TO: Casey Adragna, Adragna Architecture
FROM: Amber Wood Hicken, Planner I
DATE: 5/5/25
SUBJECT: Douglas 234 Multitenant, Site Plan
Review Comments 01

HORSE CREEK COMMERCIAL

Description: **Douglas 234 F6 AMD 2 L10B - Commercial Building**

EXTERIOR ELEVATIONS
 DOUGAS 234 FILING NO. 6, AMD. 2
 DATE: FEBRUARY 17, 2025

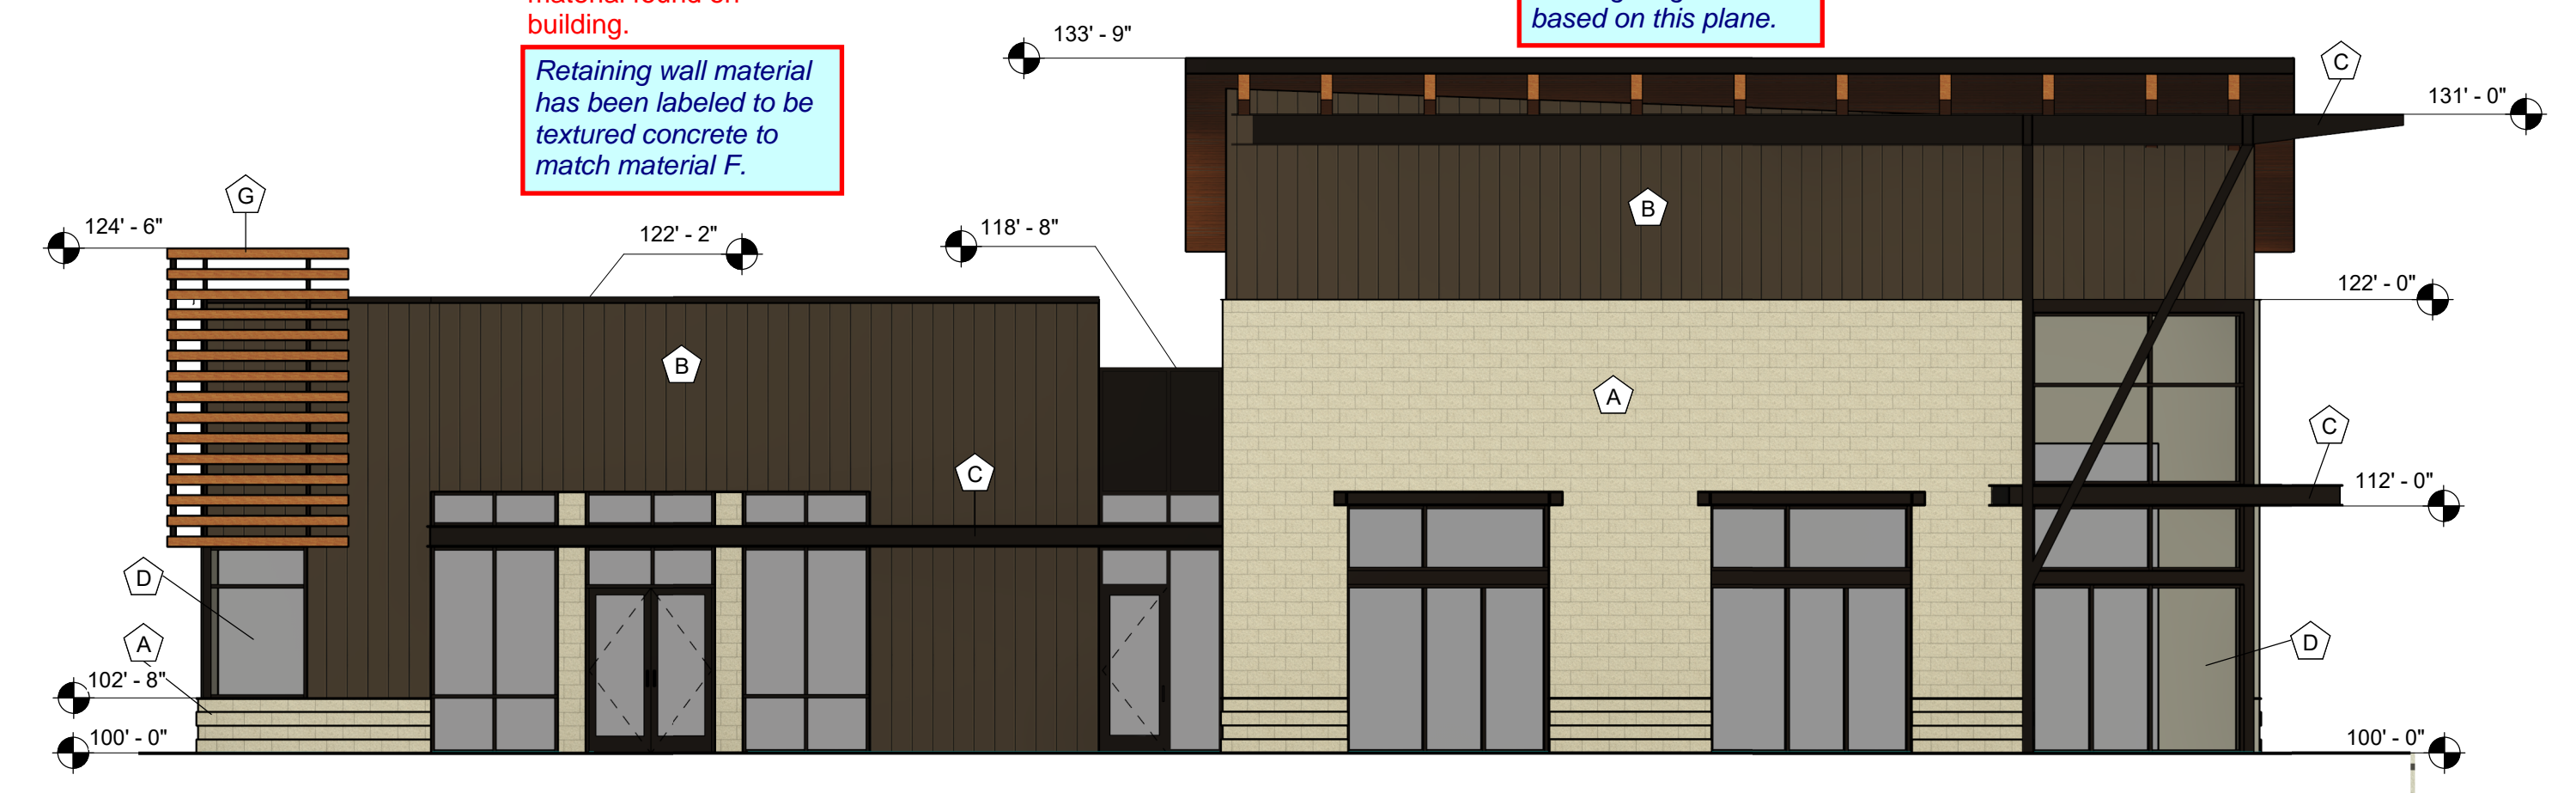
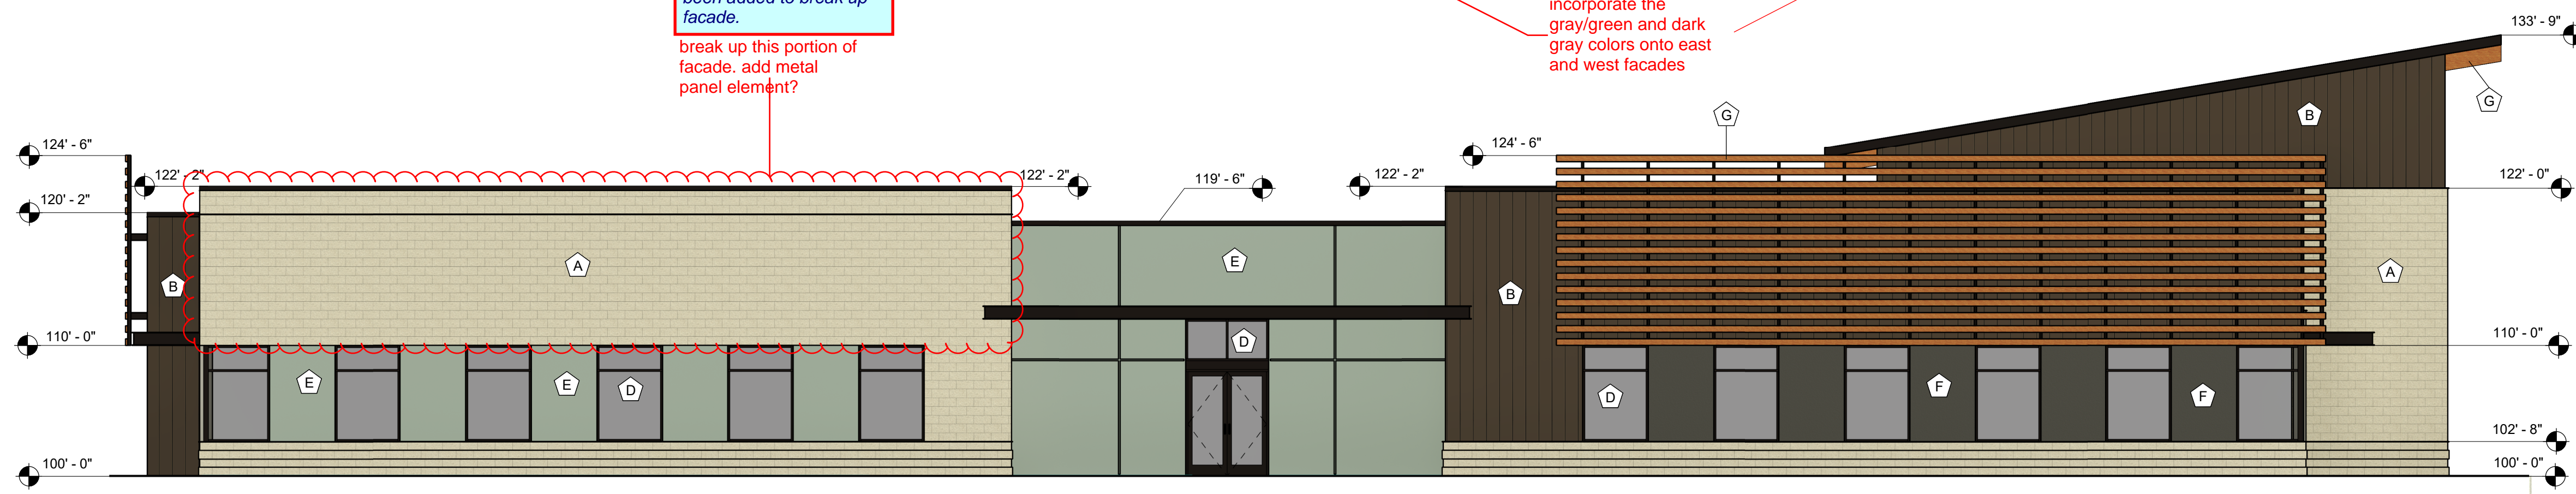
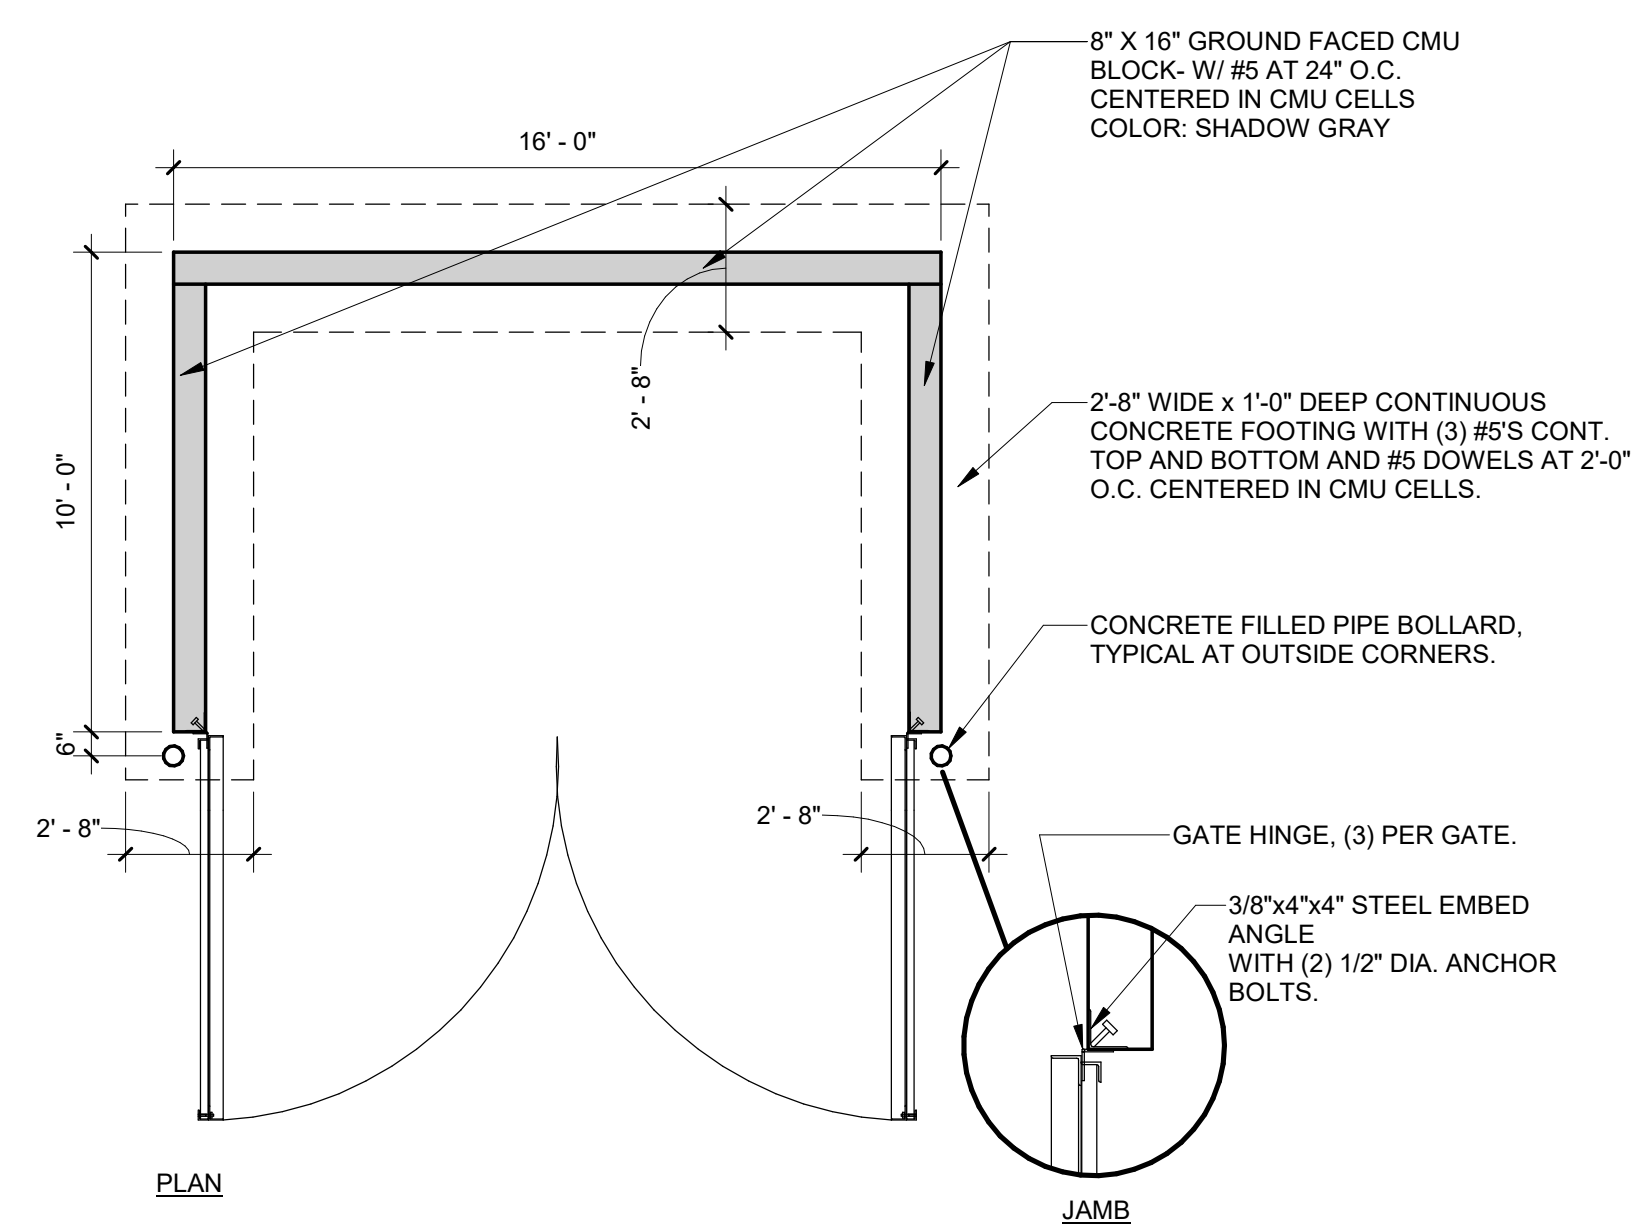
provide transparency calculations on all facades. measured between 2'-8" applies as follows:

north - 25%
 east - 25%
 south - 30%
 west - 30%

CMU may be used as an accent material only, switch for higher quality. consider brick or stone veneer.

stucco can only make up 30% of a facade. provide percentage/square footage

label material of foundation walls. use material found on building.

incorporate the gray/green and dark gray colors onto east and west facades

Transparency calcs have now been provided.

cmu material has now been revised to brick veneer.

Stucco calcs have now been provided.

Retaining wall material has been labeled to be textured concrete to match material F.

building height is measured from grade
 An average grade plan has been provided and building height is now based on this plane.

Metal panel material has been added to break up facade.
 break up this portion of facade. add metal panel element?

Gray/green stucco has now been incorporated into east and west facades.

1 TRASH ENCLOSURE
 SCALE: 1/4" = 1'-0"

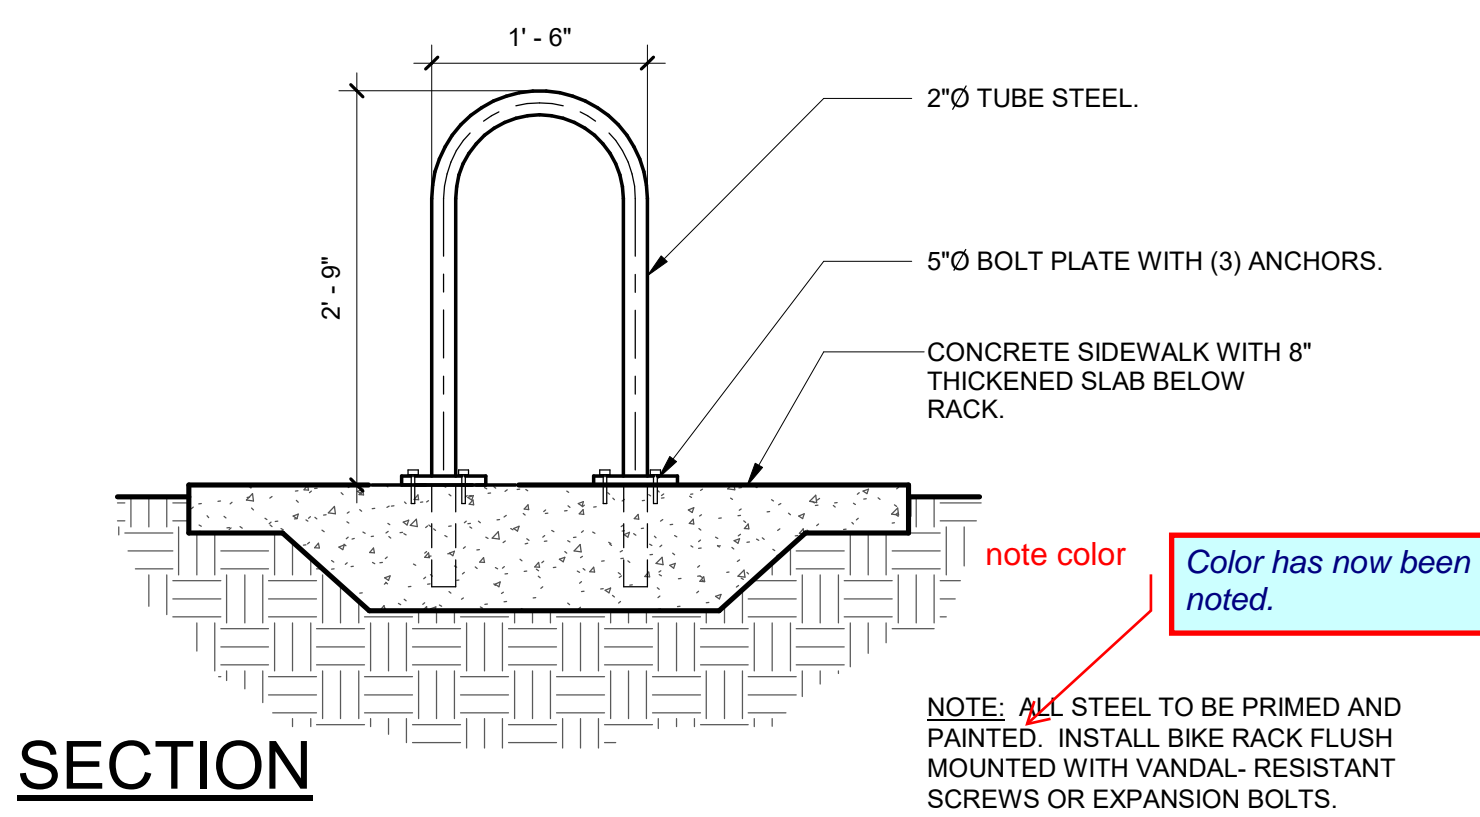
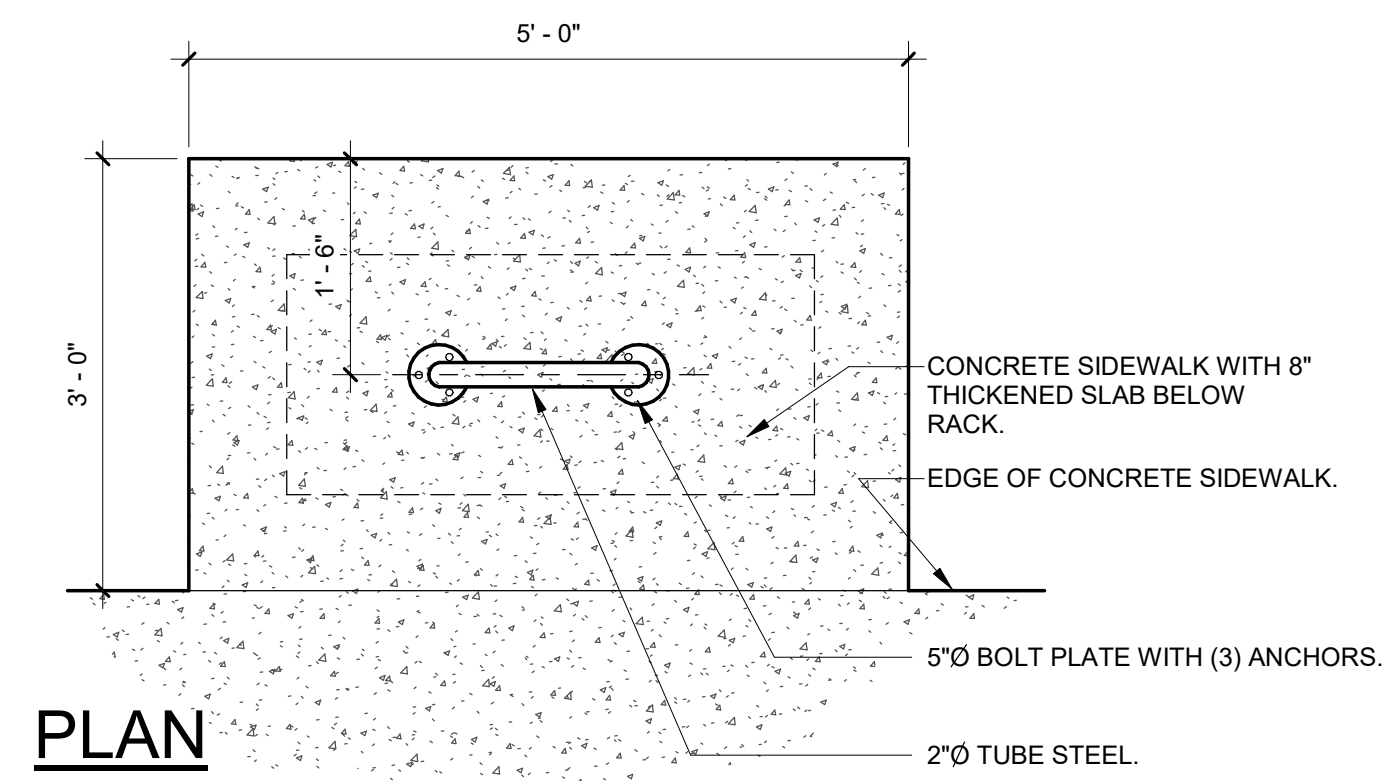
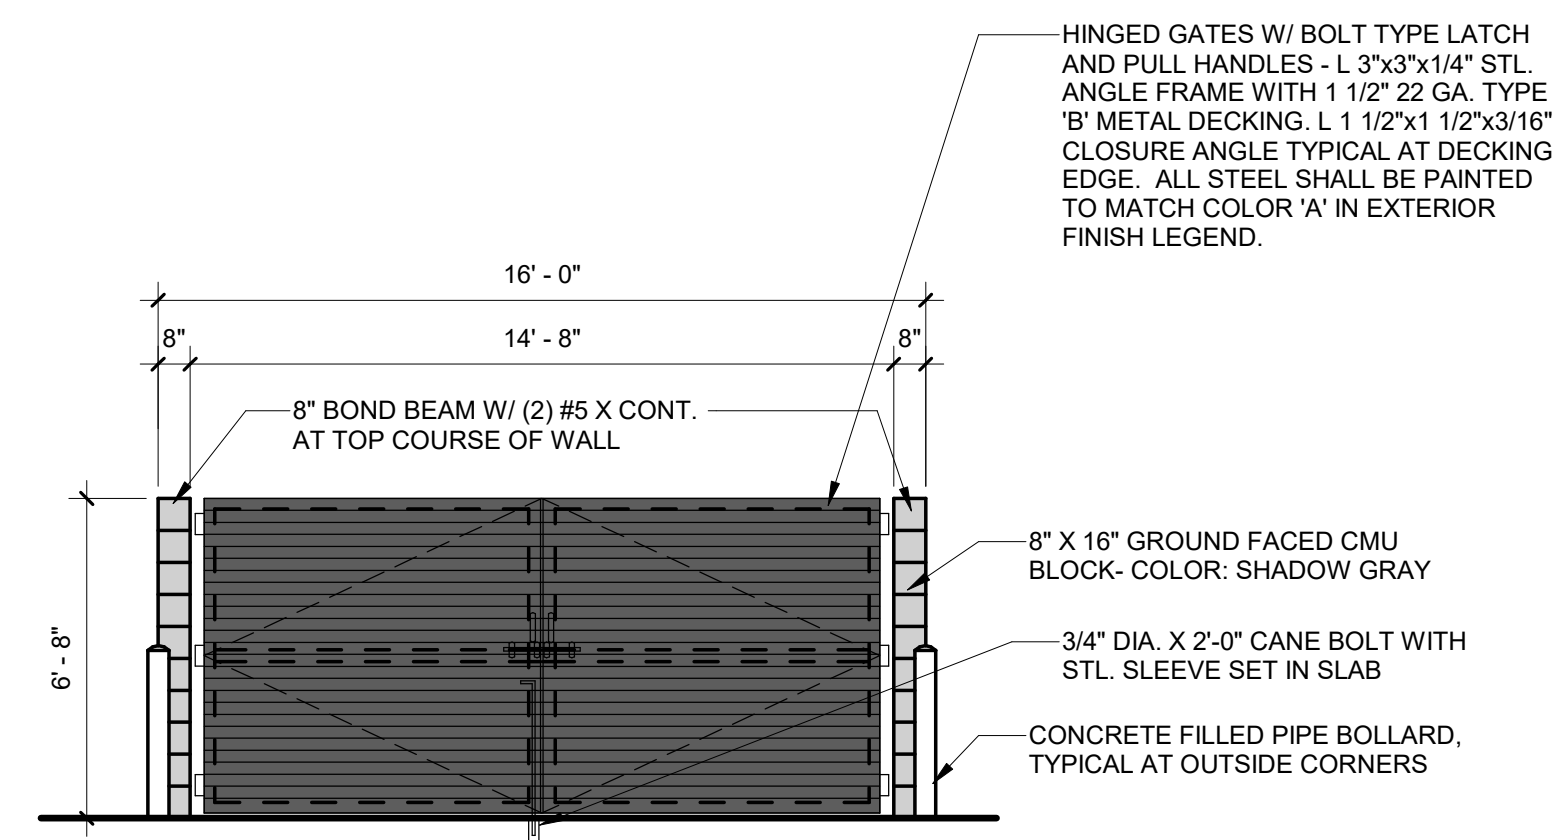
materials legend, elevations needed for all sides of enclosure

All sides of trash enclosure have now been provided to show material finish.
